# UNITED STATES PATENT AND TRADEMARK OFFICE

10/730,759

**Office Action Summary**

## **DETAILED ACTION**

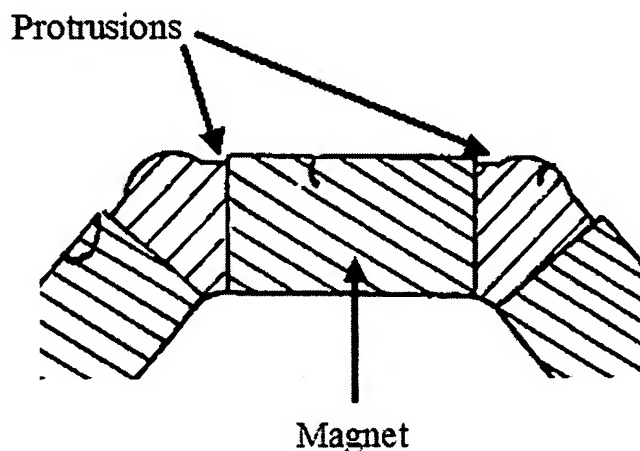
With respect to claims 15, 26 & 32, Steem teaches an electric machine comprising: A stator (as seen in Fig. 3, #14); and a rotor (Fig. 9, #93) mounted for rotation with respect to the stator, the rotor core comprising a number of magnetic slots (Fig. 9, #101 & 102) each slot comprising opposed end portions (Fig. 9, #117) and a central portion disposed between the end portions, the central portion of each of the magnet slots shaped to complementarily receive a magnet, the opposed end portions separated from the central portion by portions of the rotor that protrude at least partially

into the slot (as seen in Fig. below); a number of magnets (Fig. 9, #103) complementarily received in the central portions of the magnet slots of the rotor; and a load absorbing material filling at least a portion of each of the end portions of the magnet slots, the permanent magnet being substantially, laterally restrained in the slot by the portion of the rotor that protrudes at least partially into the slot.

portion of the rotor core that protrudes at least partially into the magnet slot (as seen in the Fig. above, and as described in Col. 8, Lines 45-47). It would have been obvious to one of ordinary skill in the art at the time of the invention to modify the magnet slot of Kliman in view of the protrusion as taught by Steem because it provides a means for locating the magnets within the magnet slot (Steem, Col. 8, Lines 45-47).
